WATER LICENCE INSPECTION FORM

Licensee				Licensee Representative						
Bonito Capital Corp. / Mandalay Reso			sources Karyn Lewis							
Licence No. / Expiry				Representative's Title						
2BM-ULU1520										
Land / Other Authorizations			Land / Other Authorizations							
IOL										
Date of Inspection			Inspector							
July 06-07, 2016			Eva Paul							
Activities Inspected ☐ Camp ☐ Roads/Hauling	Drilling Other: Ca	re + Mainte	☐ Mining nance		nstruction ner:		Reclamation	⊠ Fı	uel Storage	;
	ceptable	. (- Unaccep	table	NA –	Not Applicable		Not Insp	pected
Water Use	Condition	Comment	Site Conditions		Condition	Comment	Haz/Mat Managen	nent	Condition	Comment
Intake/Screen	NA		Water Management	Structures	U	1,3	Storage		U	9
Flow Measure. Device	NA		Culverts / Bridges		U	4	Spills		U	9
Source: West Lake	NA		Drainage		С	4	Spill Plan		U	9
Water Use:	NA		Erosion / Sediment	t	U	4				
Recirculation (y/n)	NA		Mitigation Measure	es	U	5	Administrative

Report #2016-KIT009-EP

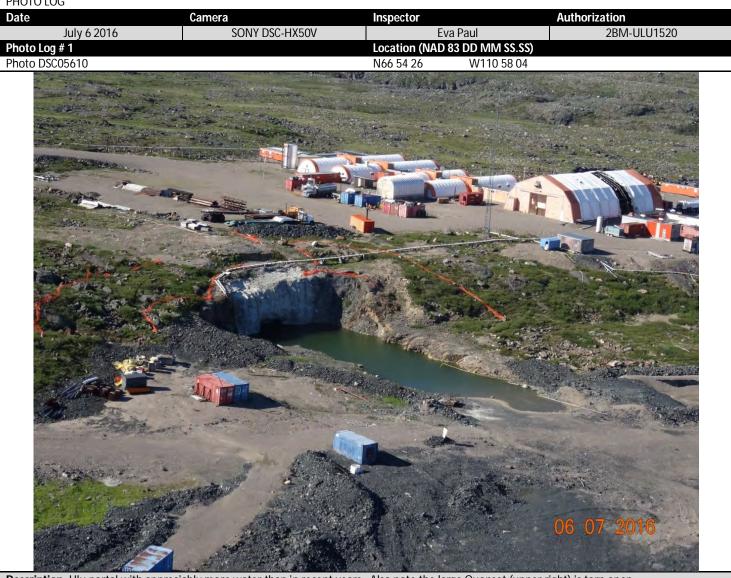
- 2. As per the 2015 report: "Waste and waste storage areas remain unidentified and waste (particularly potentially-hazardous waste) is not being stored according to the Waste Management Plan. Unmarked barrels of unidentifiable waste (with staining underneath) remain to the east of the helipad... and at the mine storage pad... there remain several barrels of [potentially] hazardous waste and contaminated soil at the mine storage pad..." Conditions remain unchanged in 2016.

Description: Barrels of assorted and potentially hazardous waste remain on the mine storage pad. Other waste (not shown here) remains elsewhere on site, including the waste rock storage pad, and near the helipad.
